MANDATORY SERVICE BULLETIN NO.
MSB 40-103 / MSB F4-042 / MSB D4-114 / MSB 40NG-084
REV. 2

Actions to prevent Passenger Door Separation: Installation of Placards, AFM Procedure update and Inspection/Data Gathering.

WORK INSTRUCTION
WI-MSB 40-103 / WI-MSB F4-042 / WI-MSB D4-114 / WI-MSB 40NG-084
REV. 2

Installation of passenger door placards and inspection of the passenger door system.

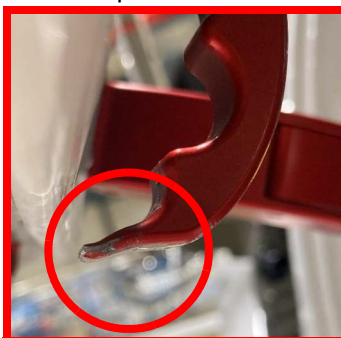
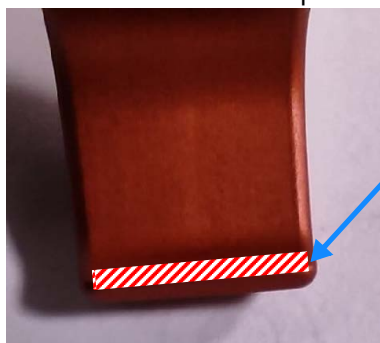
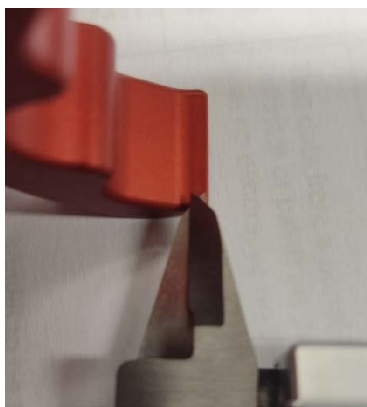
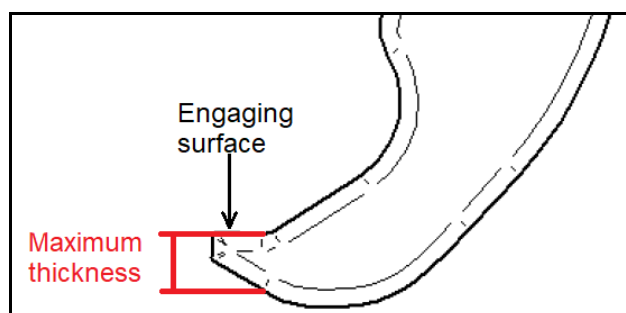
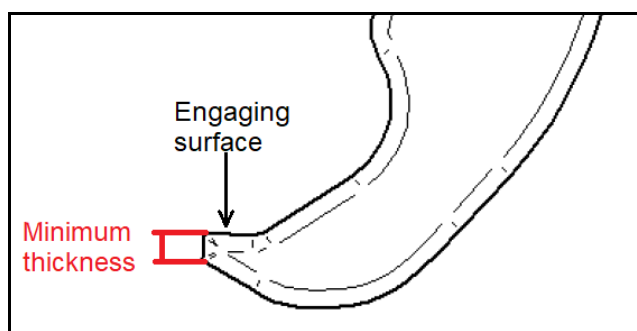
- a) Check the contact area of the push button.
- Grooves in the safety hook must be less than 2 mm deep.

- b) Examine the hook end of the safety hook.

- The hook end must not be bent.

- Wear of edges of safety hook.
- The width of the tip of the safety hook must be greater than 10.5mm.

- It must not have any steps and ridges.
- Scratches or uniform wear of surface protection are acceptable.

- The width must be greater than 1.5 mm.

- f) Measure the maximum thickness of the safety hook at the location of the engaging surface, perpendicular to the engaging surface.
- The maximum thickness must be greater than 2.5 mm.
 - The variation of thickness measured along the width of the safety hook must be less than 0.2 mm.

- g) Measure the minimum thickness of the safety hook at the location of the engaging surface, perpendicular to the engaging surface.
- The minimum thickness must be greater than 1.5 mm.
 - The variation of thickness measured along the width of the safety hook must be less than 0.2 mm.

- h) If the safety hook does not meet one or more of the acceptable conditions listed above on sub-steps **a** through **g**, take note to replace the safety hook after this WI is completed. Refer to Section IV for replacement of the safety hook.

Figure 2.

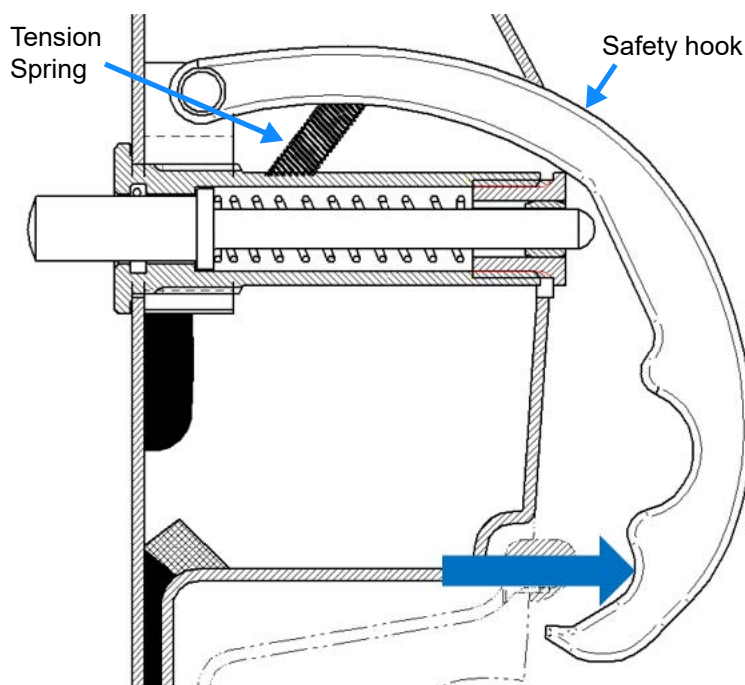
6. Check the condition of the tension spring and the force to lift the safety hook from its resting position as follows:
Refer to Figure 2.
- Open the passenger door.

- Examine the tension spring of the safety hook. Use a borescope through cutout in the door, if corrosion, deformation or damage is found, take note and replace it after this WI is completed. Refer to Section IV for removal and installation of the hook assembly.

- Lift the safety hook and release it.
 - After releasing the force, the safety hook must snap back into its resting position.
 - If the safety hook does not snap back into its resting position, do the following:

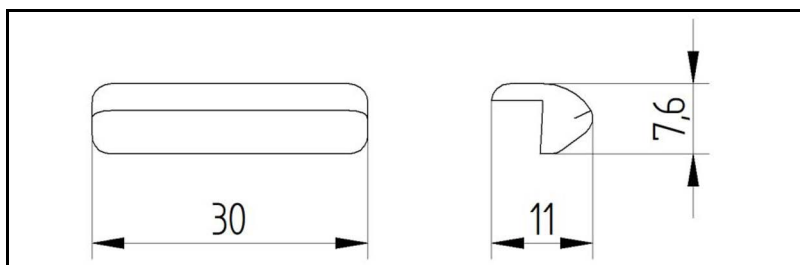
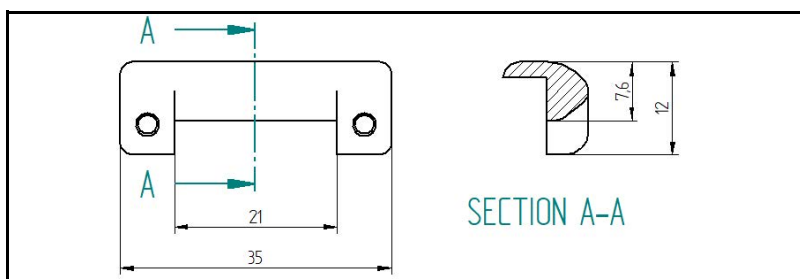
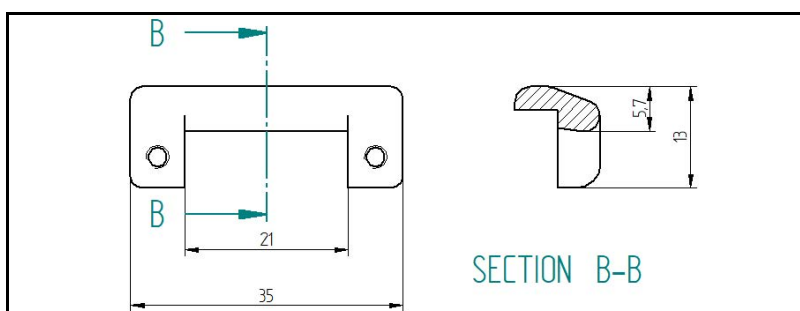
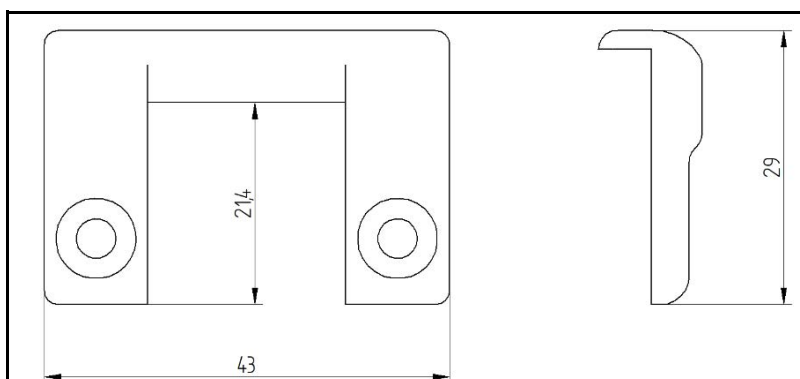
7. Identify the version of the retaining block:
Record the version in the execution report.

Small (DA4-5200-00-69)

Extended without undercut (DA4-5200-00-69_1)

Extended with undercut (DA4-5200-00-69_02)

Long extended (DA4-5200-00-69-SB)

Figure 4.

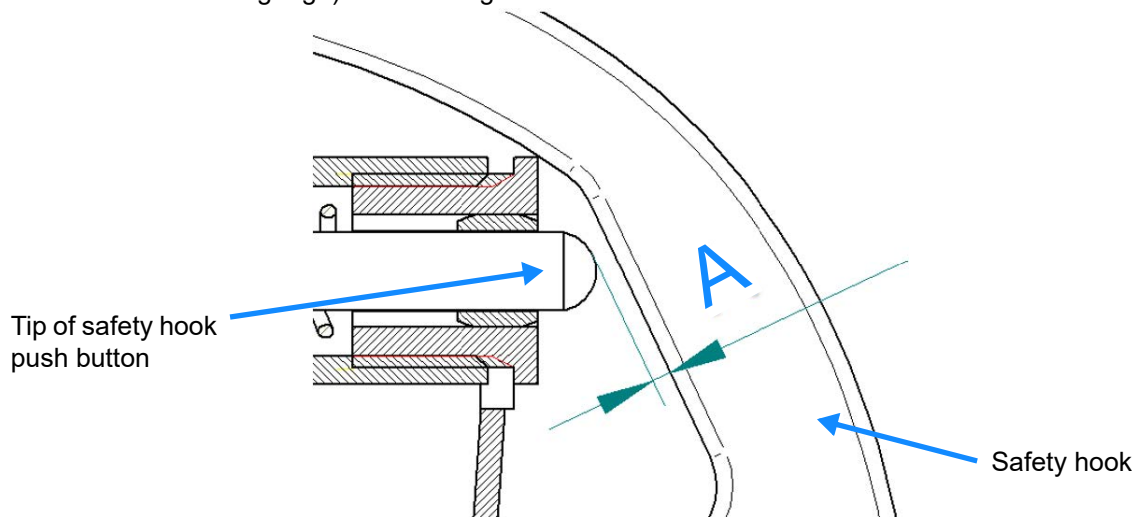
- Dimension A: distance of push button to the safety hook in resting position (e.g. with a feeler gauge). Refer to Figure 4.

Figure 5.

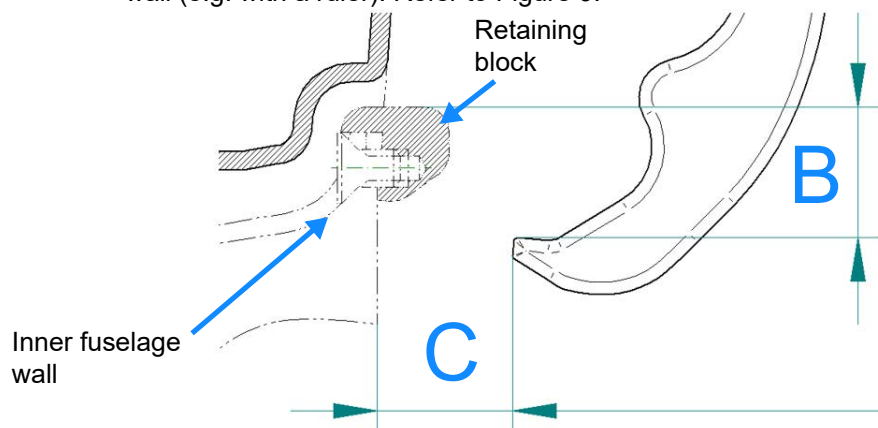
- Dimension B: distance between the top surface of the retaining block to the top surface of the engaging section of the safety hook in resting position (e.g. with a ruler). Refer to Figure 5.
- Dimension C: horizontal distance between the tip of the safety hook and the fuselage wall (e.g. with a ruler). Refer to Figure 9.

Figure 6.

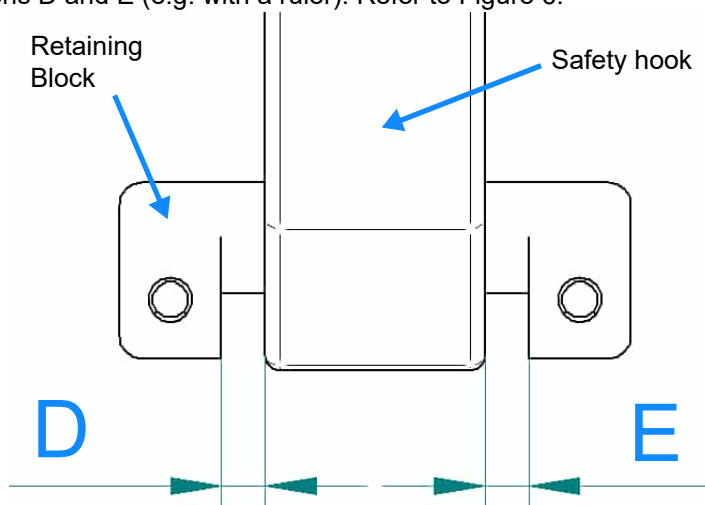
- c) Unlatch the passenger door and push the passenger door open, engaging the safety hook into the retaining block. Apply slight pressure to the passenger door to keep the safety hook engaged during the measurement.
- d) Record the measurements on the execution report in Appendix A.

- Dimensions D and E (e.g. with a ruler). Refer to Figure 6.

Figure 10.

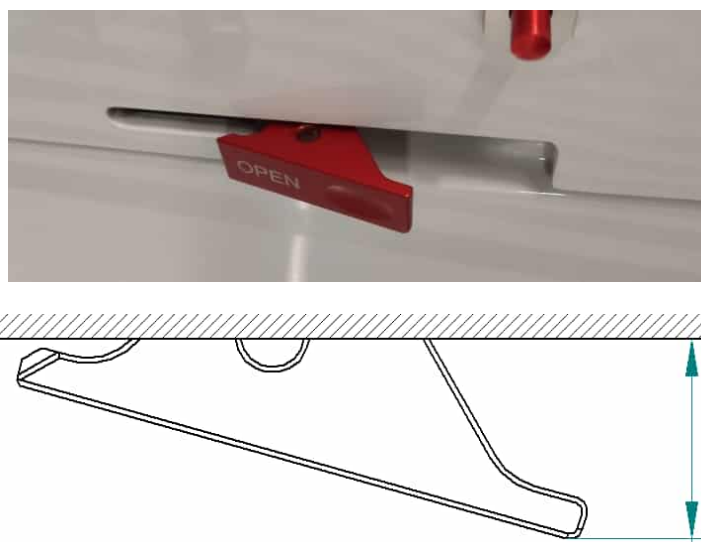
15. If the old passenger door latch is installed (refer to step 14), visually inspect the spring:
Refer to Figure 10.
- a) Move the passenger door handle to the unlatched position.
 - b) Visually inspect the spring.
 - Look specifically for a broken winding, replace the spring if found broken.
 - c) Record any findings on the execution report in Appendix A.

Figure 11. Protrusion measurement

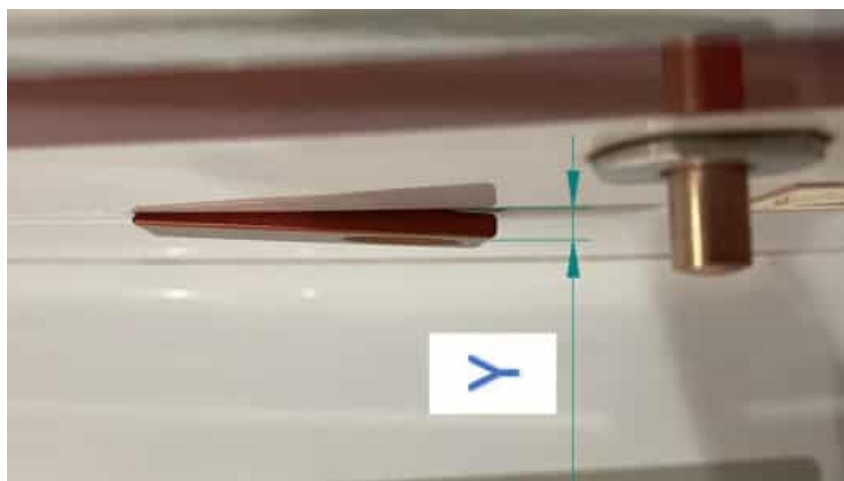
19. Data collection: Position of the external passenger door handle. Refer to Figures 11 and 12.

- a) Close the passenger door.
- b) Push the external passenger door handle into the latched position until it stops.
- c) Examine if the passenger door handle is recessed, flush or protruding over the passenger door surface.
- d) Record the condition of the passenger door handle on the execution report in Appendix A.
- e) If the handle protrudes from the surface of the passenger door, measure the protrusion.
- f) Record the measurement on the execution report in Appendix A.

Figure 18. Example of **NOT** acceptable condition of door guide block

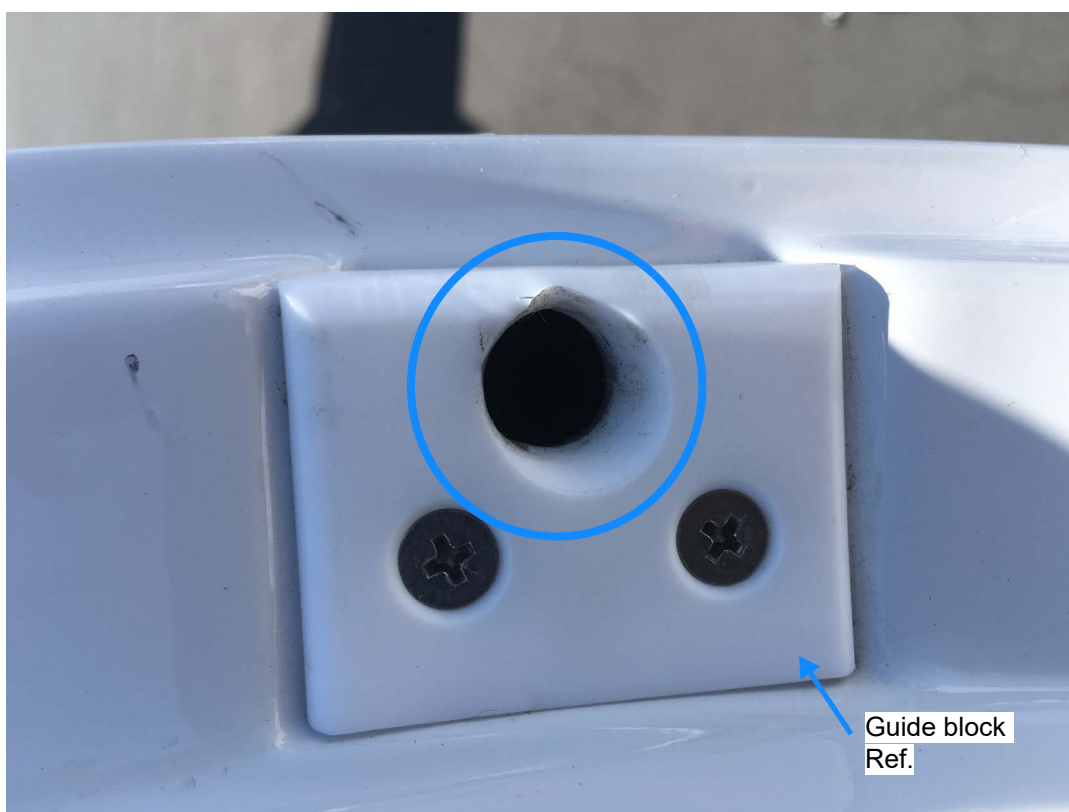
23. Inspect the front and rear door guide block for damage. Refer to Figure 18.

- a) Open the passenger door.
- b) Visually check the condition of the guide block.
 - The guide block must not have worn edges, dents, cracks.
 - If you found any damage, take note and replace the guide block after the WI is completed. Refer to section IV for the replacement.
 - Record any damage of the guide blocks on the execution report in Appendix A.

Figure 29.

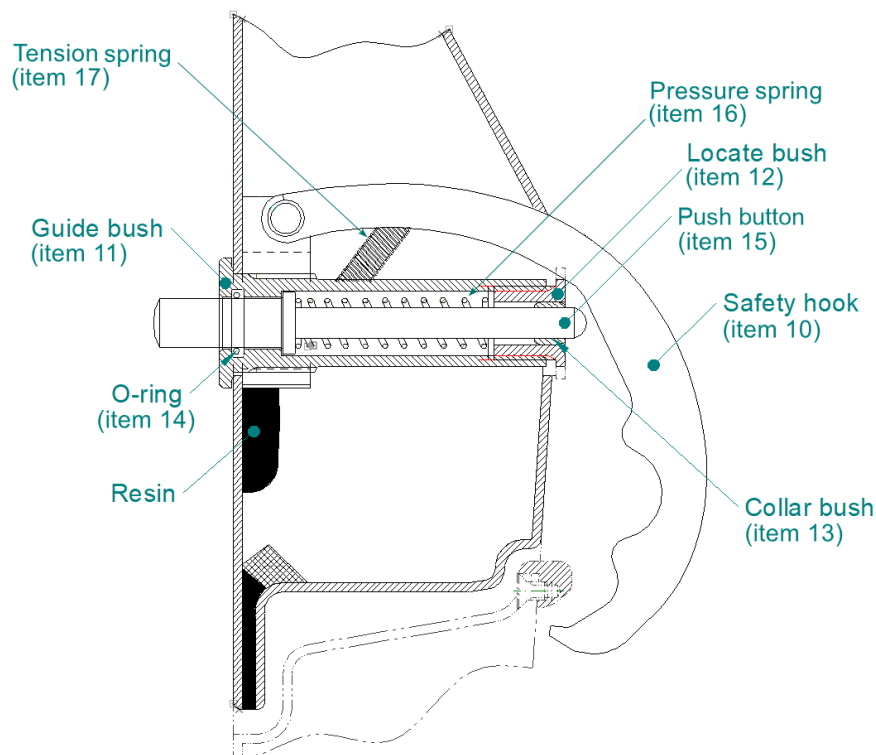
Refer to Figure 29.

NOTE: To replace the safety hook or push button, the hook assembly (safety hook and push button) needs to be removed from the airplane and taken to a work table for disassembly.

1. Remove the inner door handle to get access to the inside of the door. Refer to AMM Section 52-10.
2. Unscrew the guide bush and locate bush to release the push button assembly.

3. Remove the hook assembly from aircraft through the handle opening and place it on a work table to replace safety hook.
4. Remove screw that secures the tension spring on the safety hook.
5. Remove cotter pin to release safety hook, pin and washers.
6. Install the new safety hook (item 10) using the pin, washers and cotter pin.
7. Reinstall tension spring using the screw to secure it. Use Loctite 262 (item 6) to screw, refer to manufacturer instructions for proper use.

8. Replace any defective parts of the push button.
9. Reinstall hook assembly to the aircraft door:
 - a) Route the hook assembly through the handle opening and secure to outside door shell with guide bush (item 11).
 - b) Insert collar bush (item 13) into locate bush (item 12).
 - c) Apply a small amount of Vaseline (item 8) to o-ring (item 14) and insert into guide bush.
 - d) Insert push button (item 15) and pressure spring (item 16) into guide bush (item 11) and screw guide bush and locate bush (item 12) together.
 - e) Apply ITW Plexus MA300 (item 9) or thickened resin (5 min epoxy + cotton flakes) to the bearing block on the inside of the door. Refer to Figure 30 and the manufacturer instructions for proper use.
10. Record the replacement on the execution report in Appendix A.

Figure 31.

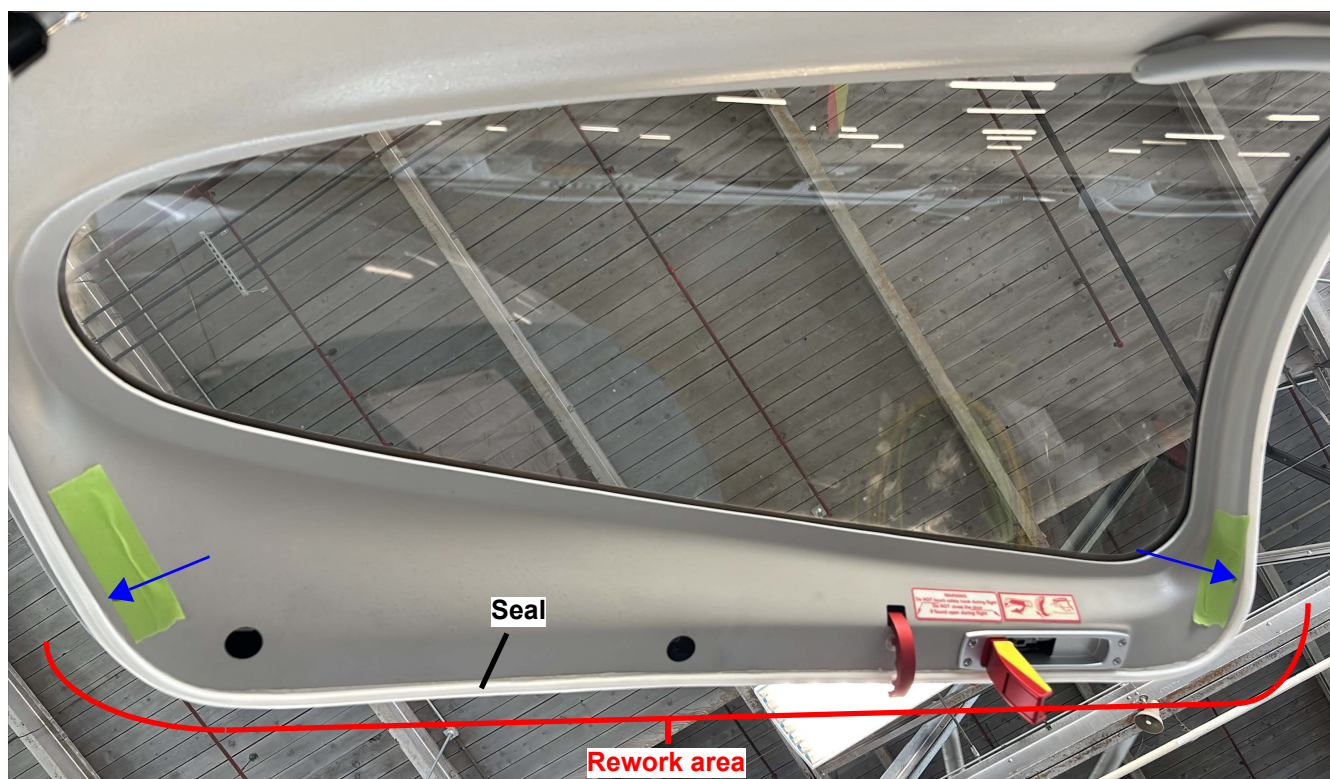
1. Carefully remove the door seal from the door only in the rework area specified in Figure 31. Be careful not to damage the seal during removal. Leave the seal hanging.
2. If required, remove existing sealant from the area where you removed the seal and clean the surface for the new sealant.
3. Apply 0-5 mm bead of clear silicone sealant (item 23) to the door.
4. Reinstall seal and allow sealant to cure. Refer to sealant manufacturers instructions.
5. Repeat step 20.c). and check if the force is between 2 kg (20 N) and 6 kg (60 N).
 - If the force is below 2 kg (20 N): Reapply sealant up to maximum allowed and repeat test. If test cannot be passed, replace gas spring.
 - If force is above 6 kg (60 N): Remove sealant, apply a thinner layer of sealant and repeat test.
